# UNITED STATES PATENT AND TRADEMARK OFFICE

## Office Action Summary

10/605,619

## DETAILED ACTION

Fig 1

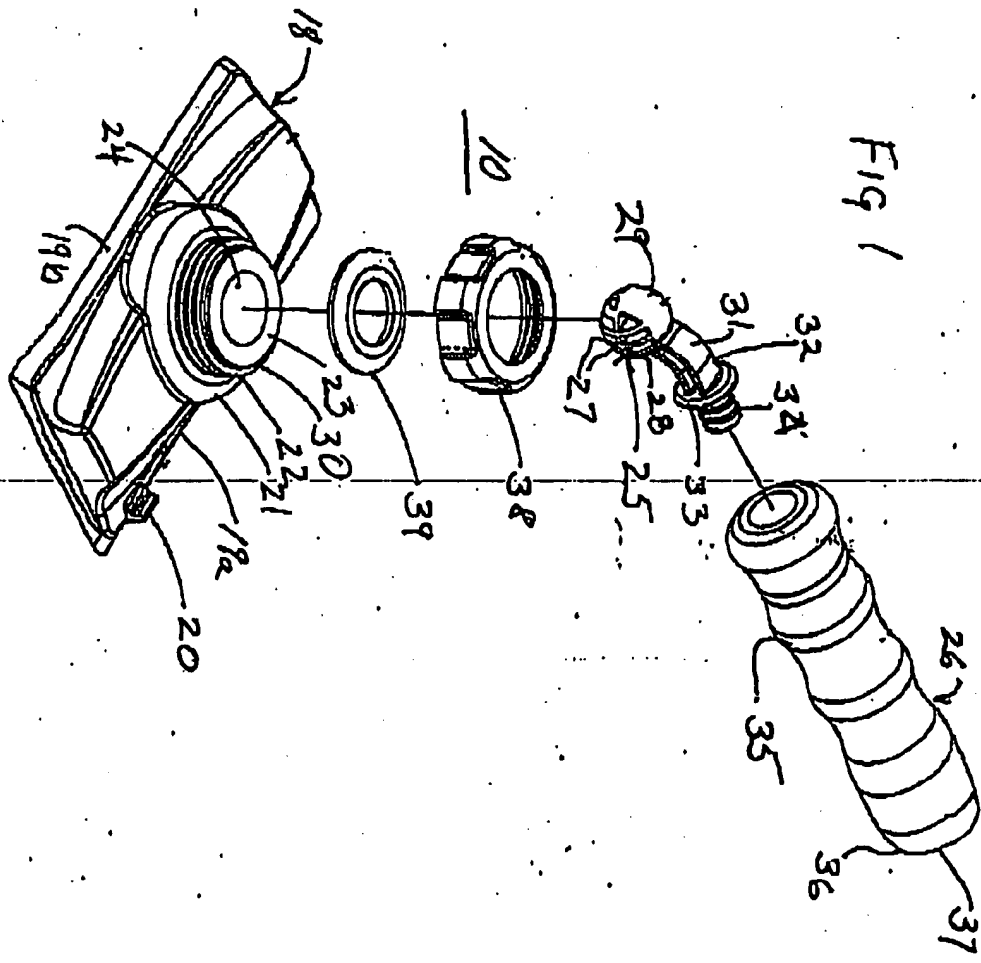
Claim 1, line 6, the recitation of "a solid handle portion having a ball at one end" makes the scope of the claims vague and indefinite since it is not exactly clear what Applicant is intending this "solid handle portion" to be. For example, viewing Fig. 1, element 28 is referred to in the specification as a **solid** base and element 29 is referred to as a **solid** portion. The claim language is confusing because it has never been disclosed that handle 26 is solid since handle 26 includes an internally threaded recess 37 as shown in Fig. 1 (which would be hollow). The handle portion 26 cannot really be considered **solid** if there is an internally threaded recess 37 at one end (Fig. 1).

A similar objection also arises in claim 4 since claim 4 recites “the ball at **one end of the handle portion** comprises a **ball integrally mounted to the solid handle portion**” (emphasis added). So, is the “solid handle portion” of claim 1 and claim 4 referring to simply the “solid base 28” (see Fig. 1)? Therefore, it is unclear what the “solid handle portion” is referring to.
